UNITED STATES PATENT AND TRADEMARK OFFICE

APPLICATION NO.	FILING DATE	FIRST NAMED INVENTOR	ATTORNEY DOCKET NO.	CONFIRMATION NO.
10/596,926	06/29/2006	Gianni Ceccherini	72NP154563	2396

Office Action Summary	Application No. 10/596,926	Applicant(s) CECCHERINI ET AL.	
	Examiner PHUTTHIWAT WONGWIAN	Art Unit 3741

DETAILED ACTION

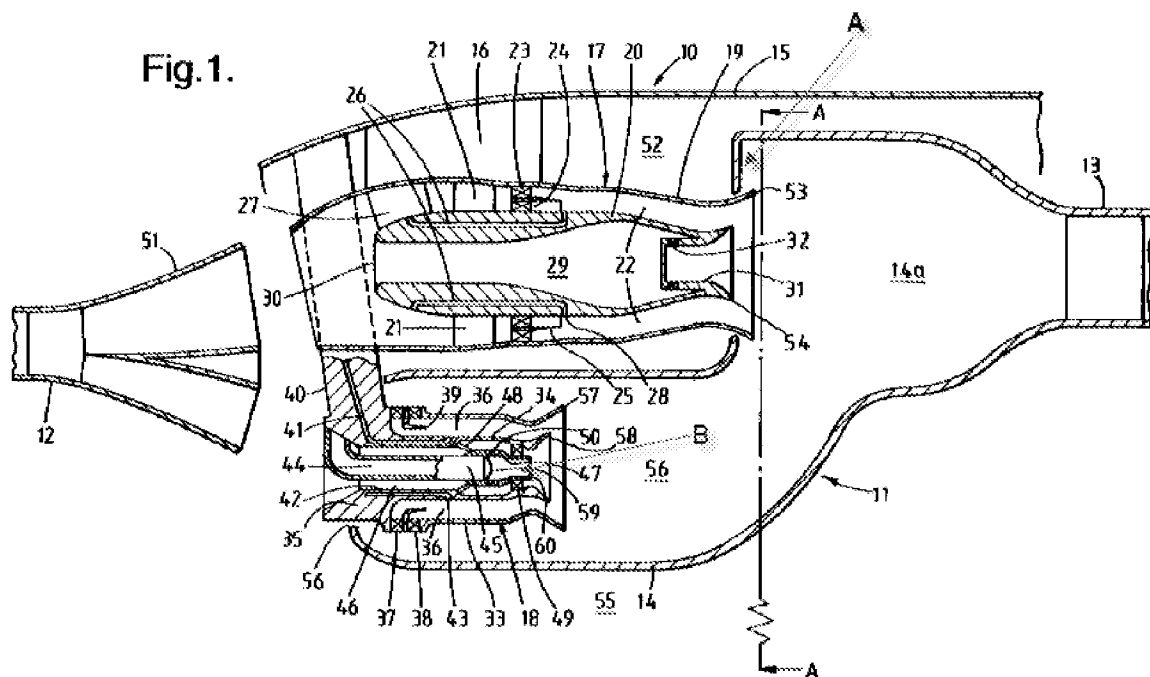
10. As to claim 1, Richardson discloses a combustion system for a gas turbine equipped with a premixing chamber 22 (fig. 1) for [intended use] air which is mixed with the fuel injected from a series of holes 28 (fig. 1) creating a main central flame which is formed in a flame tube 14a (fig. 1), the premixing chamber is convergent toward a connected end A (fig. 1, above part of the premix chamber is convergent toward a connected end) with a combustion chamber comprising the flame tube 14a (fig. 1); and a series of pilot devices 18 (fig. 1 and fig. 2) configured to premix the fuel gas and create a series of corresponding pilot flames suitable [desired result] for stabilizing the main central flame itself [desired result], at the same time reducing the pollution emissions [desired result], each of series of pilot includes a sub-pilot device 41, 42 (fig.

1, the passages 41, 41 are considered to be a pilot sub-device, since they inject fuel to the pilot device 18) configured to inject pilot fuel gas into the respective pilot device and produce [desire result] diffusion flames for stabilizing the pilot flame.

11. As to claim 6, Richardson discloses each pilot devices 18 (fig. 1 and fig. 2) of the series of pilot devices with premixing of the fuel gas comprises a premixing duct 33 (fig. 1) a series of holes 42 (fig. 1) for the fuel gas inside the premixing duct and a unit 18 (fig. 1) comprising at least one shaped element 39 (fig. 1) so as to create turbulence [intended use] in the air flow in order to obtain [desired result] a homogenous mixture of air/fuel gas inside of the premixing chamber itself.

12. As to claim 7, Richardson discloses at least one shaped element comprises a series of shaped blades 37 (fig. 1, the swirler vanes are considered to be the shape blades).

13. As to claim 8, Richardson discloses at least one shaped element comprises two series of shaped blades 37, 38 (fig. 1).

14. As to claim 9, Richardson discloses the series of fuel gas premixing pilot devices comprises a duct 41 (fig. 1) for [intended use] the fuel gas, situated in a central elements 34 (fig. 1) inside the premixing chamber 36 (fig. 1) for [desired result] stabilizing the flame of the pilot device itself, the duct 41 (fig. 1) is inside and coaxial to an annual duct 34 (fig. 1) for [intended use] the fuel gas in turn connected to the series of holes.

15. As to claim 11, Richardson discloses the series of fuel gas premixing pilot devices comprises a mini-burner B (fig. 1 above) inside the premixing duct for [desired result] stabilization the flame of the pilot device itself.

26. As to claim 12, Richardson discloses a series of holes 49, 50 (fig. 1) for air and the mini-burner B (fig. 1 above) is connected to a duct 44 (fig. 1) for the fuel gas inside and coaxial to an annular duct 36 (fig. 1) for the fuel gas, in turn connected to the series of holes 41 (fig. 1, the fuel passage injects fuel through the holes).
